Appendix R

Siting of Meteorological Instruments

Appendix S

Justification for Use of 15 Years of Scottsbluff's Meteorological Data

FIGURE S-1
WIND DIRECTION CORRELATION
FOR SCOTTSBLUFF AIRPORT

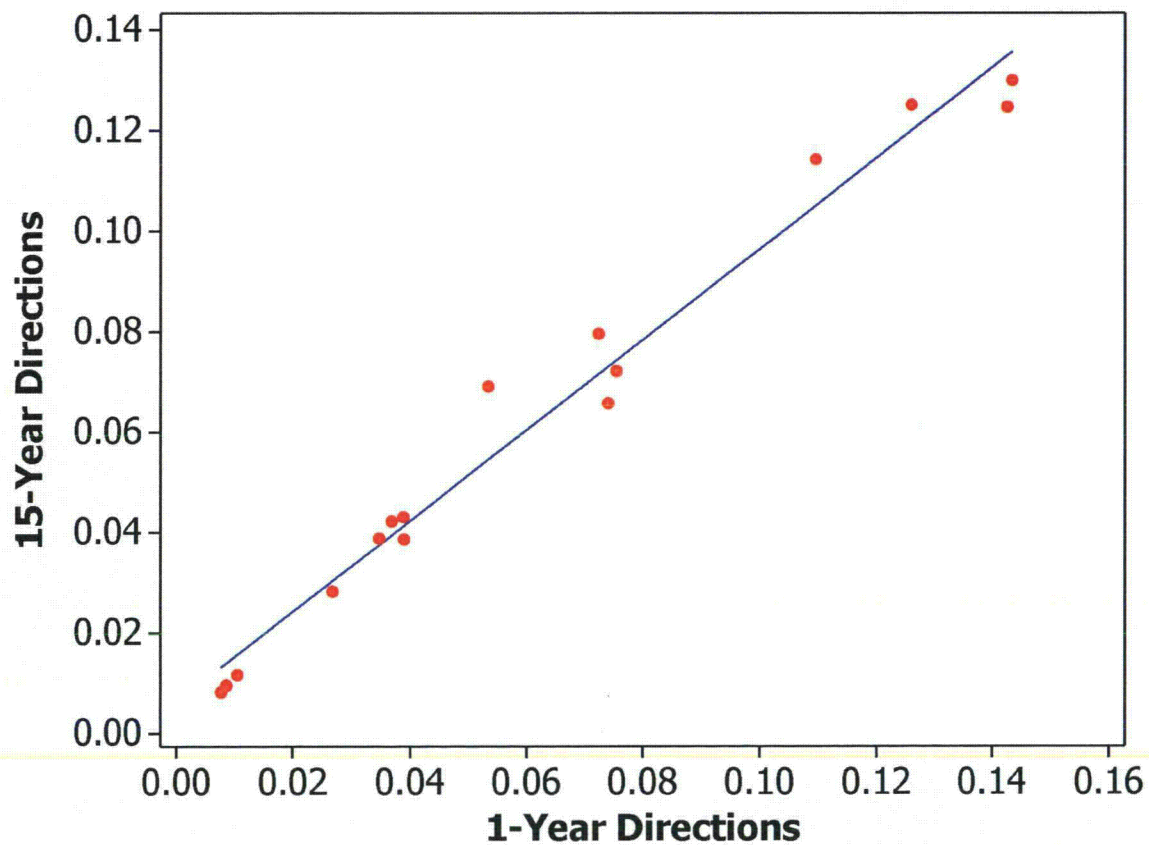
The regression analyses for wind parameters at the Scottsbluff meteorological station are repeated below with p-values as requested in NRC Comment #4 a). As seen in **Figure S-1**, the wind direction correlation produced a very high coefficient of determination, or R^2 . In the wind direction regression analysis below, the p-value of 0.000 indicates virtually no chance that this R^2 value is accidental. In other words, the 1-year distribution of wind directions is strongly correlated with the 15-year distribution, to a high degree of confidence.

Scottsbluff Regression Analysis: 15-Year Directions versus 1-Year Directions

The regression equation is:

$$15\text{-Year Directions} = 0.006077 + 0.9028 \quad 1\text{-Year Directions}$$

$$S = 0.00689141 \quad R\text{-Sq} = 97.5\% \quad R\text{-Sq(adj)} = 97.4\%$$

Analysis of Variance

Source	DF	SS	MS	F	P
Regression	1	0.0262411	0.0262411	552.54	0.000
Error	14	0.0006649	0.0000475		
Total	15	0.0269060

FIGURE S-2
WIND SPEED CORRELATION
FOR SCOTTSBLUFF AIRPORT

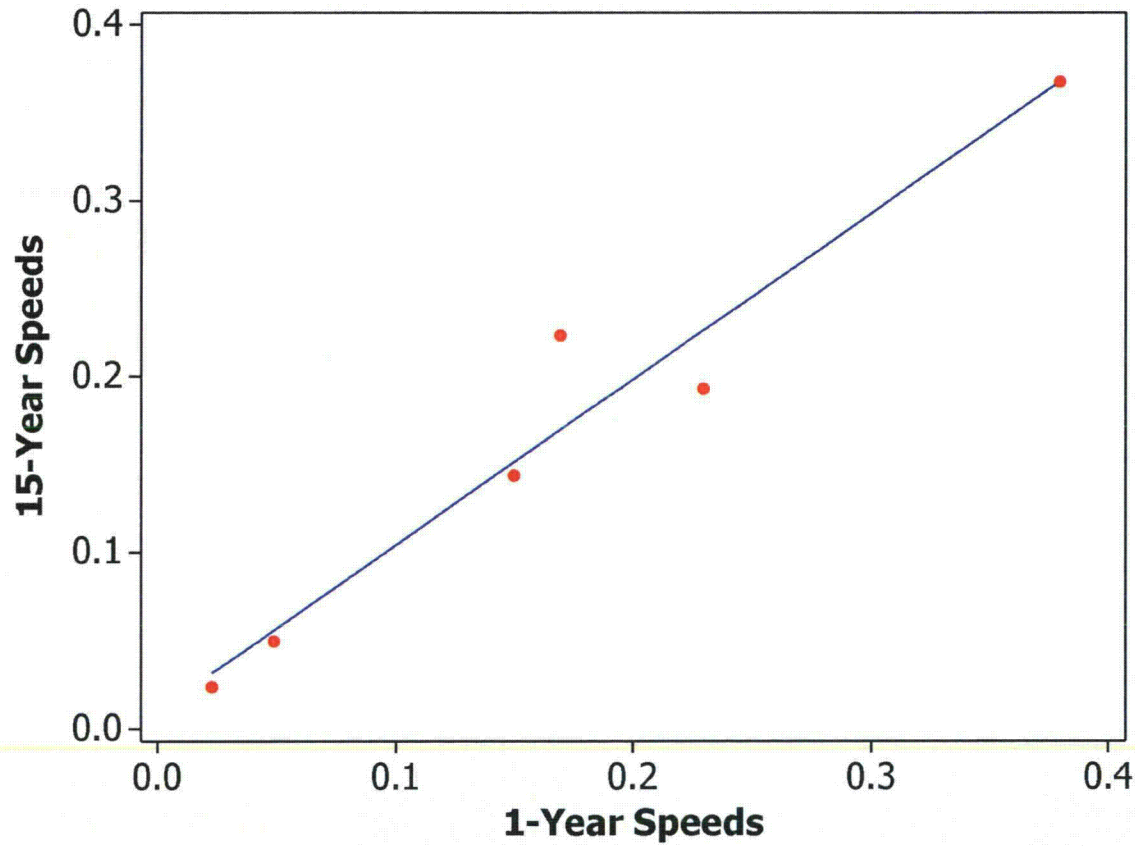
In similar fashion, the wind speed correlation produced a very high coefficient of determination (**Figure S-2**). The p-value of 0.001 shown in the regression analysis below indicates a 99.9% confidence that this R^2 value is not accidental. In other words, the 1-year distribution of wind speeds is strongly correlated with the 15-year distribution, to a high degree of confidence.

Scottsbluff Regression Analysis: 15-Year Speeds versus 1-Year Speeds

The regression equation is:

$$15\text{-Year Speeds} = 0.00959 + 0.9425 \quad 1\text{-Year Speeds}$$

$$S = 0.0321279 \quad R\text{-Sq} = 94.8\% \quad R\text{-Sq(adj)} = 93.5\%$$

Analysis of Variance

Source	DF	SS	MS	F	P
Regression	1	0.0748612	0.0748612	72.53	0.001
Error	4	0.0041288	0.0010322		
Total	5	0.0789900

FIGURE S-3
BASELINE-YEAR WIND ROSE
CHADRON AIRPORT

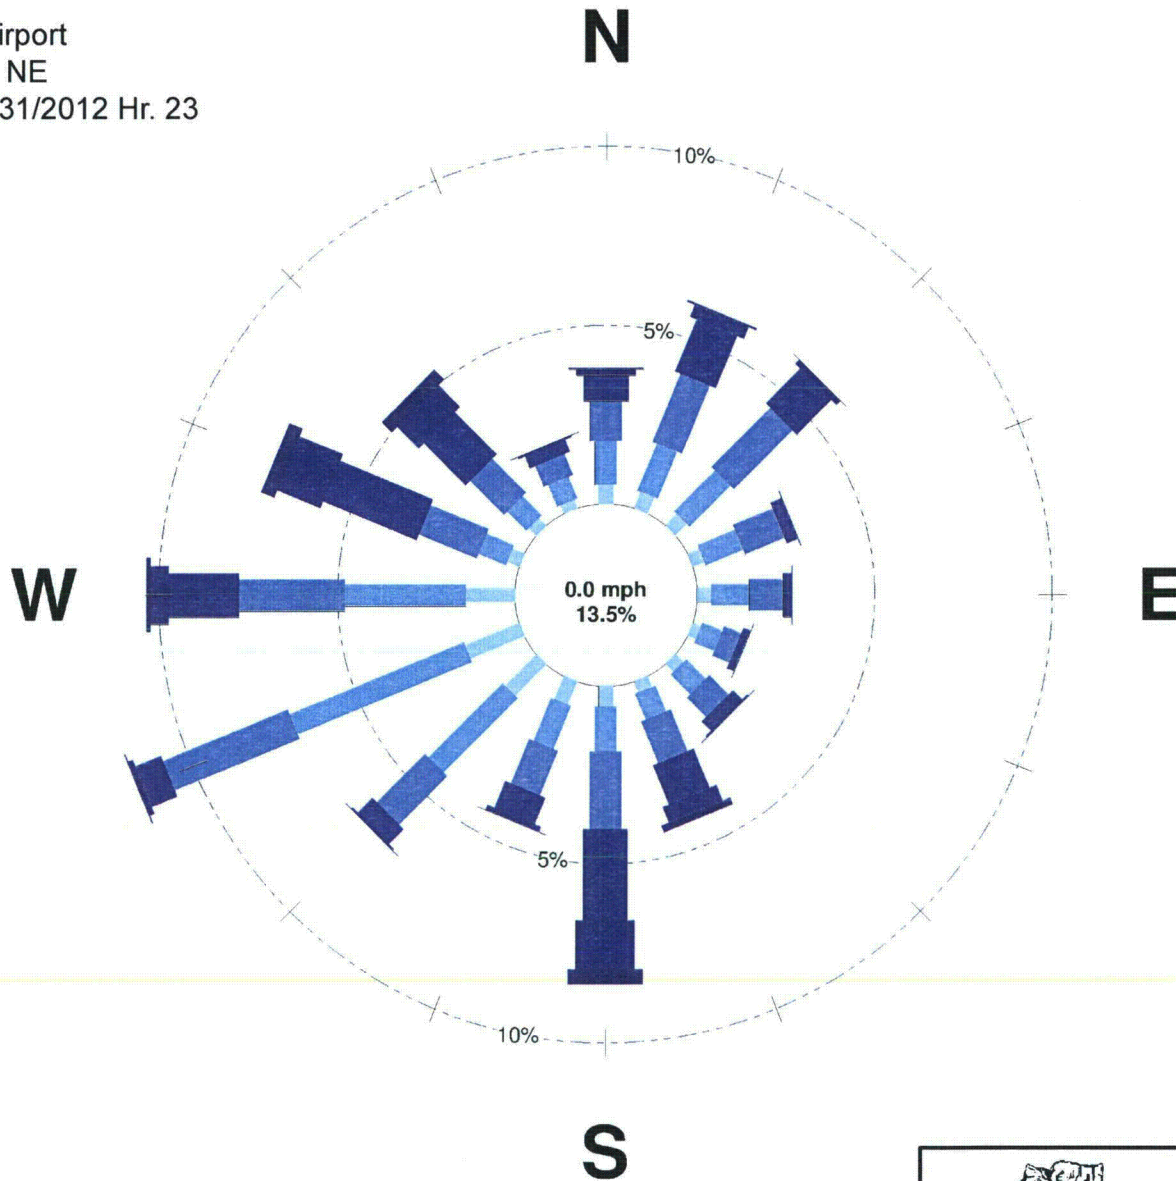
In response to NRC Comment #4 b), hourly wind data were retrieved from the Chadron airport meteorological station. **Figures S-3** and **S-4** illustrate strong similarities between the baseline year and the 12-year period from 2001 through 2012.

FIGURE S-5
CHADRON AIRPORT
WIND DIRECTION DISTRIBUTION

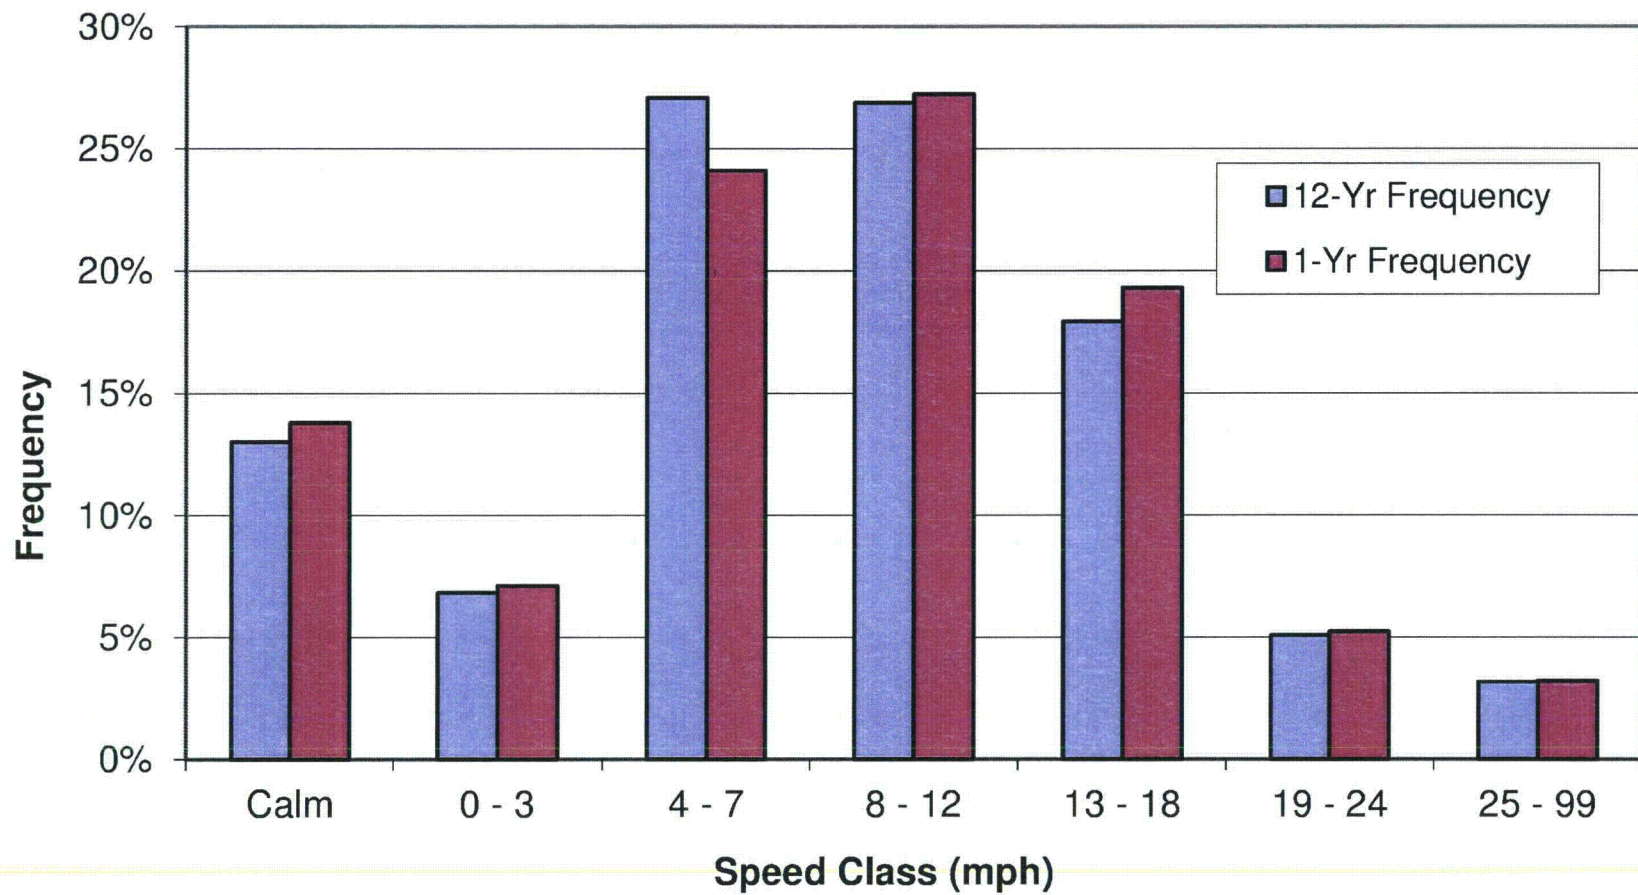
The similarities in **Figures S-5** and **S-6** are further illustrated by comparing the bar graphs of wind direction and wind speed distributions between the baseline year and the 12-year period (**Figures S-5** and **S-6**).

FIGURE S-7
WIND DIRECTION CORRELATION
FOR CHADRON AIRPORT

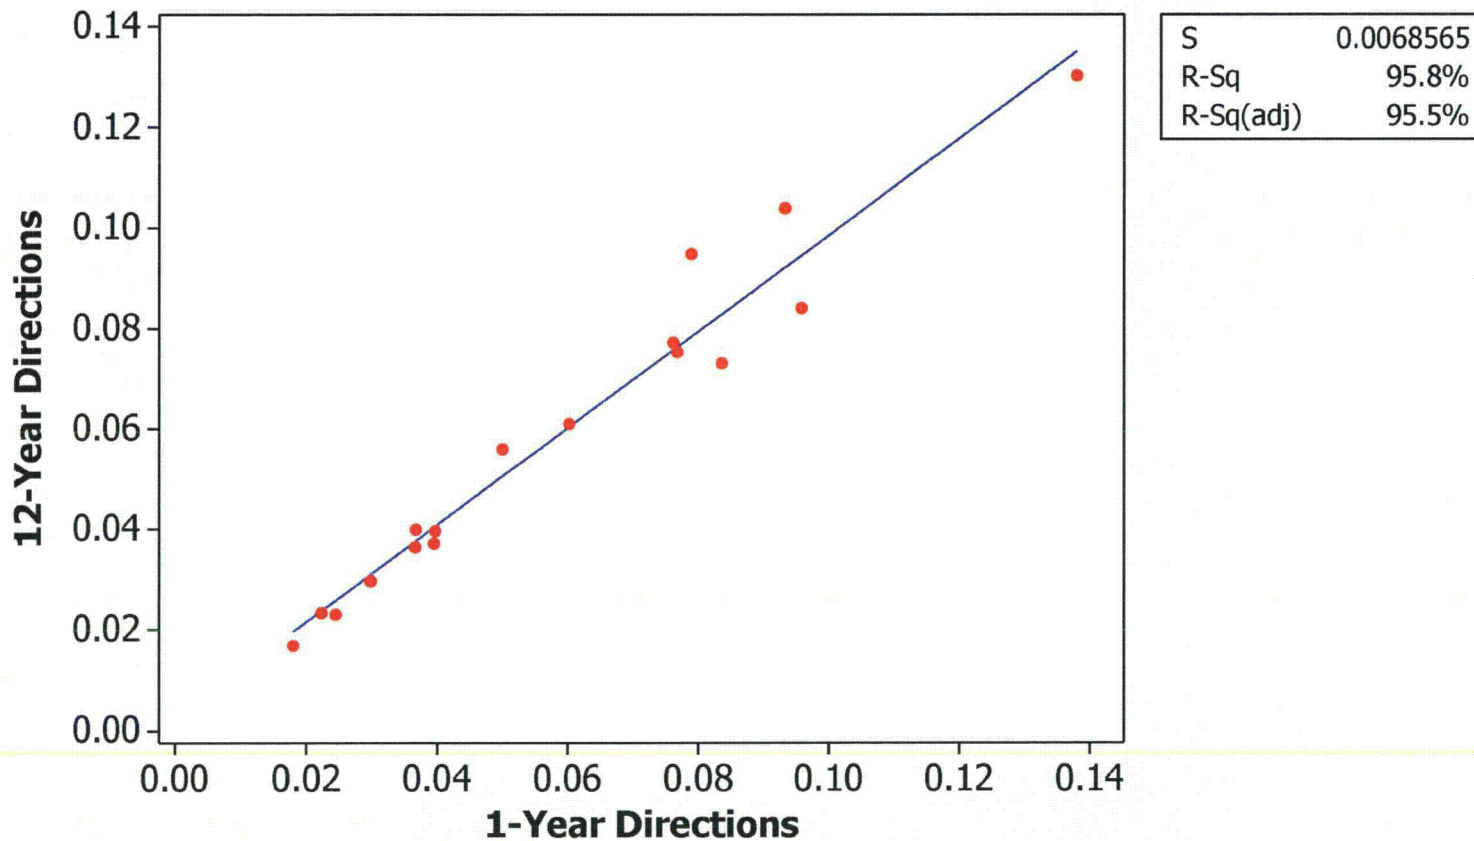
The regression analyses for wind parameters at the Chadron meteorological station are presented below with p-values as requested in NRC Comment #4 a). **Figure S-7** shows the wind direction correlation produced a very high coefficient of determination, or R^2 . As seen in the regression analysis below, the p-value of 0.000 indicates virtually no chance that this R^2 value is accidental. In other words, the 1-year distribution of wind directions is strongly correlated with the 12-year distribution, to a high degree of confidence.

Chadron Regression Analysis: 12-Year Directions versus 1-Year Directions

The regression equation is:

$$12\text{-Year Directions} = 0.002237 + 0.9618 \quad 1\text{-Year Directions}$$

$$S = 0.00685647 \quad R\text{-Sq} = 95.8\% \quad R\text{-Sq(adj)} = 95.5\%$$

Analysis of Variance

Source	DF	SS	MS	F	P
Regression	1	0.0160024	0.0160024	340.39	0.000
Error	15	0.0007052	0.0000470		
Total	16	0.0167075

FIGURE S-8
WIND SPEED CORRELATION
FOR CHADRON AIRPORT

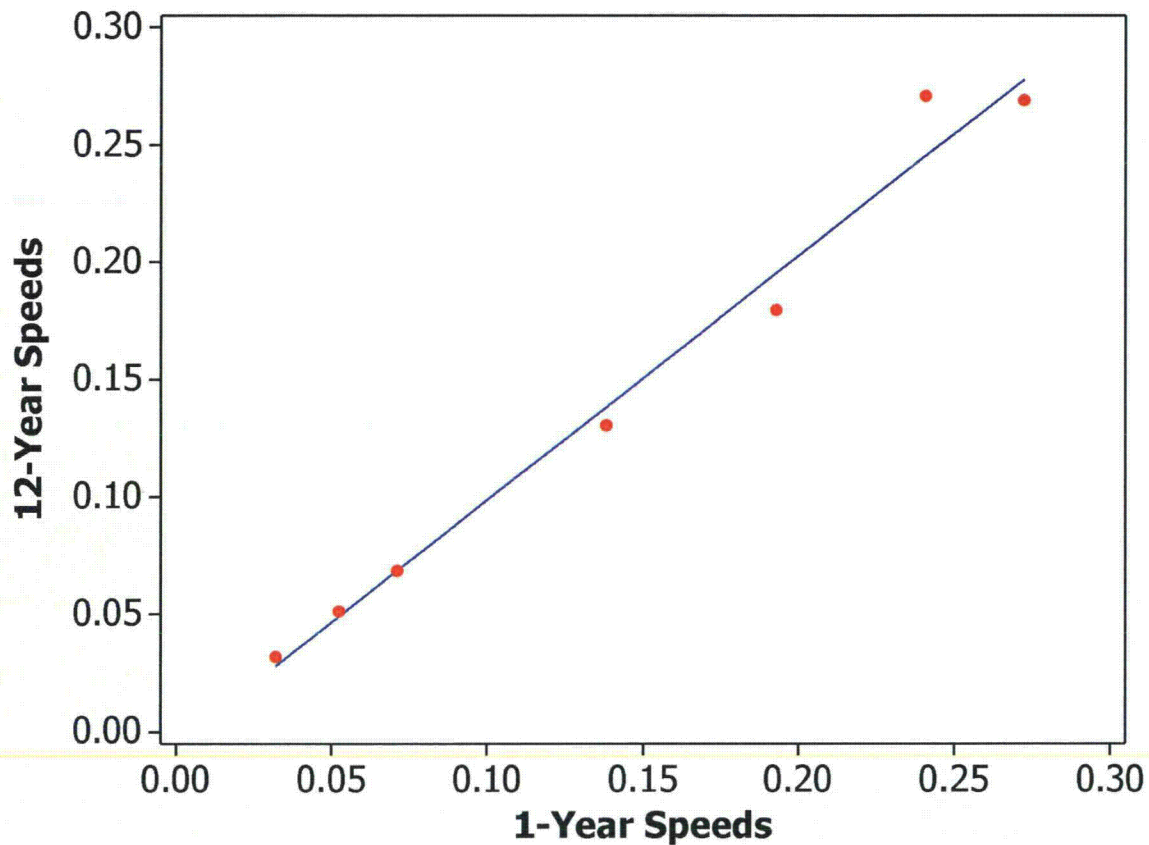
In similar fashion, the wind speed correlation for Chadron produced a very high coefficient of determination (**Figure S-8**). The p-value of 0.000 shown in the regression analysis below indicates virtual certainty that this R^2 value is not accidental. In other words, the 1-year distribution of wind speeds is strongly correlated with the 12-year distribution, to a high degree of confidence.

Chadron Regression Analysis: 12-Year Speeds versus 1-Year Speeds

The regression equation is:

$$12\text{-Year Speeds} = - 0.00580 + 1.04 \quad 1\text{-Year Speeds}$$

$$S = 0.0146045 \quad R\text{-Sq} = 98.2\% \quad R\text{-Sq(adj)} = 97.9\%$$

Analysis of Variance

Source	DF	SS	MS	F	P
Regression	1	0.0590527	0.0590527	276.86	0.000
Error	5	0.0010665	0.0002133		
Total	6	0.0601191
